Village of Arlington Heights
Plan Commission
Board Room, 3rd Floor
Arlington Heights Village Hall
33 S. Arlington Heights Road
Arlington Heights, IL 60005
February 27, 2019
7:30 PM

- A. 1400 W. Thomas St. Subdivision - PC#18-025
Preliminary Plat of Subdivision, Rezoning, Comprehensive Plan
Amendment
- B. Goddard School - 1316 N. Arlington Heights Rd. - PC#18-023
Rezoning, PUD, Variations
- C. Verizon Wireless Cell Tower - 1122 W. Rand Rd. - PC#18-024
LUV for Commercial Antennas, Variations

RE: 7-ELEVEN GAS STATION - 1650 WEST ALGONQUIN ROAD - PC# 18-026
SPECIAL USE PERMIT FOR AUTO SERVICE (GAS) STATION, VARIATION

C-1

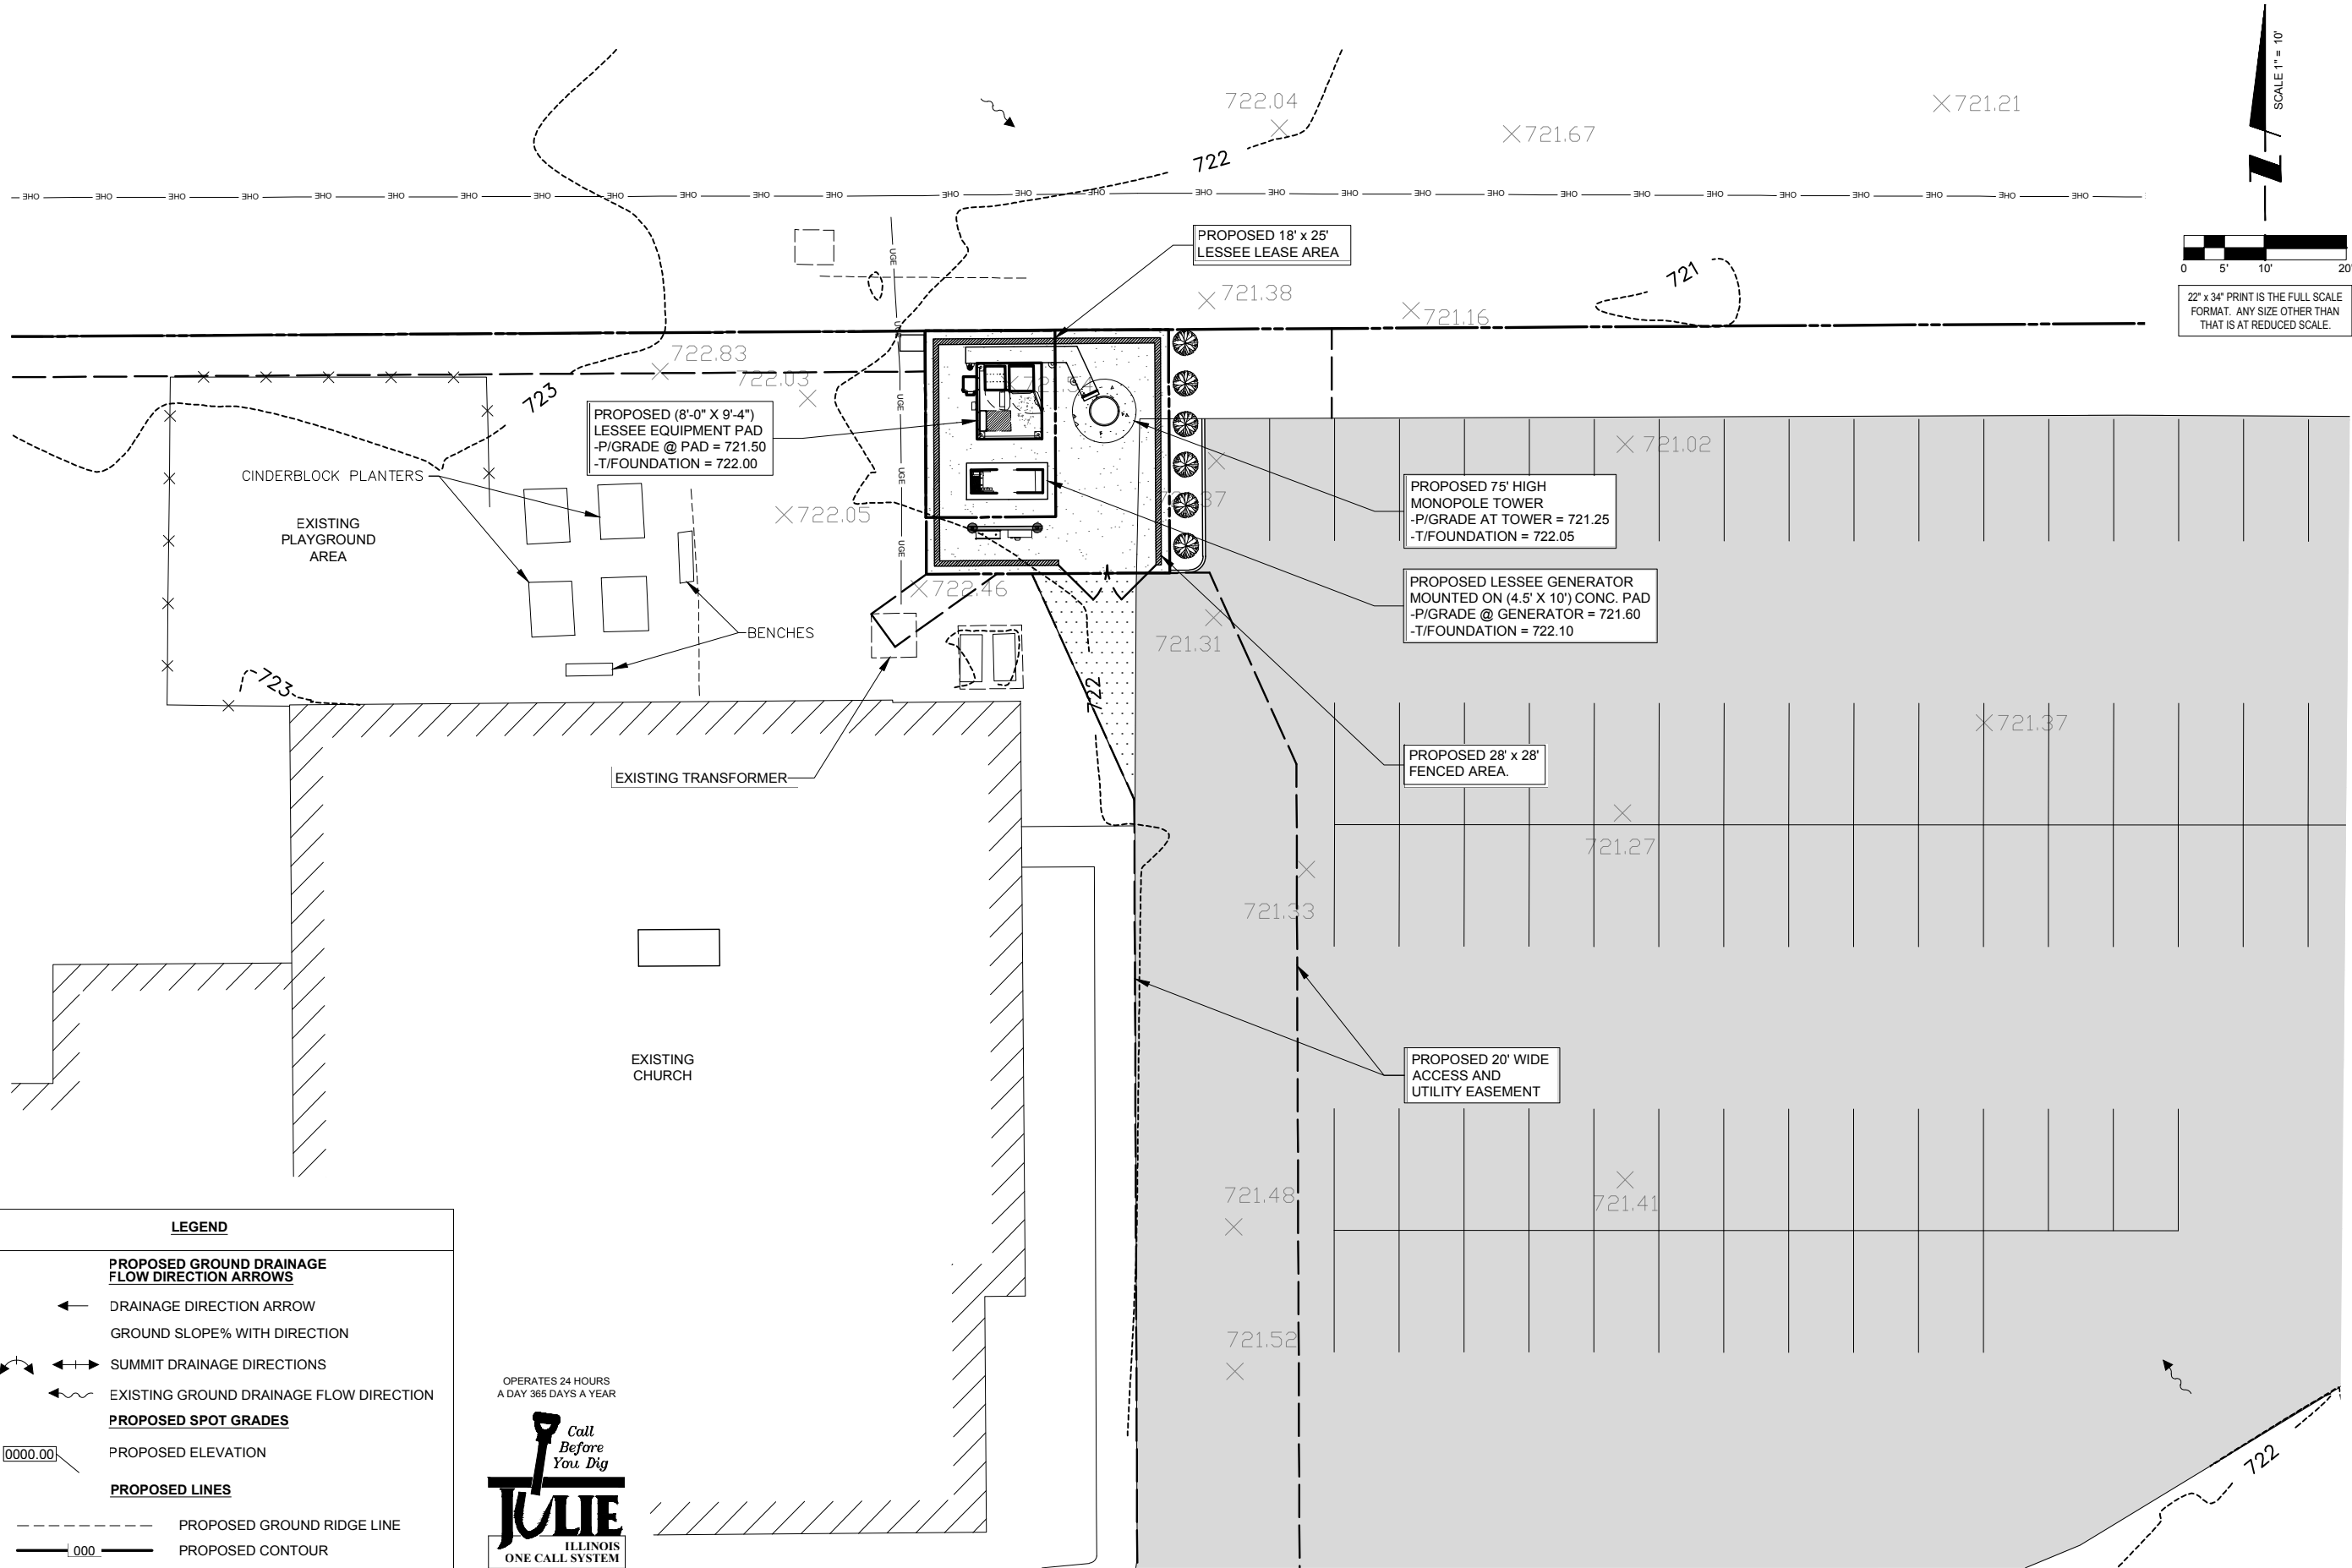
17. Sheet C-1 has a note indicating that the lease area is 222 square yards. Please clarify. Other documentation indicates that the lease area is 30' x 30'. Is the 222 "S.Y" referencing something else?

17. Sheet C-1 has a note indicating that the lease area is 222 square yards. Please clarify. Other documentation indicates that the lease area is 30' x 30'. Is the 222 "S.Y" referencing something else? **A&E to address in the plans**
